2 Type of change

Product Change Notification					PCN FMLB-51 FSW-65 case 49 redesign		
owner	creation date	release date	released by	change order no	rev	page	D10-041-505
segatro	04.12.2019	10.12.2019	canoniar	2018653	A	1 of 2

Old product appearance (example)	New product appearance (example)

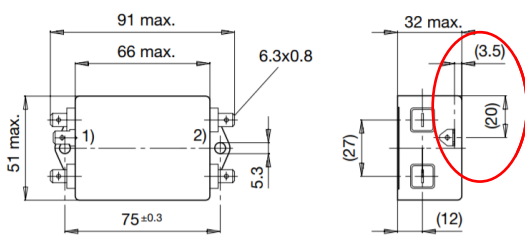
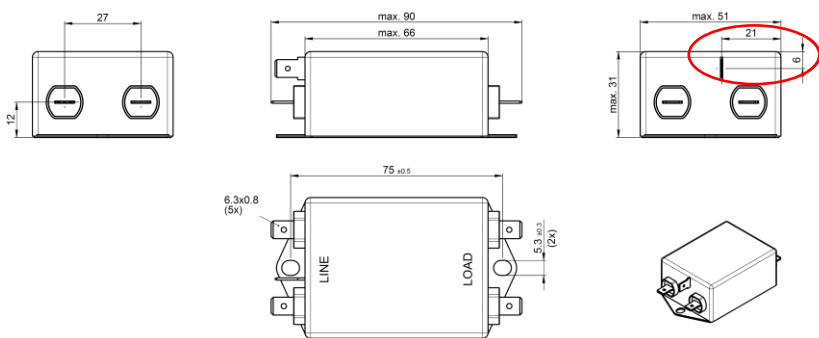
- Change of product appearance due to new nickel plated steel case instead of aluminium case
- Different shape of plastic part for external quick connector terminals
- Moved position and turned protective earth terminal to a vertical position
- New cases are provided with a bottom cover
- Change of factory code from SK to SC and origin from SK to CN on product and packaging labels
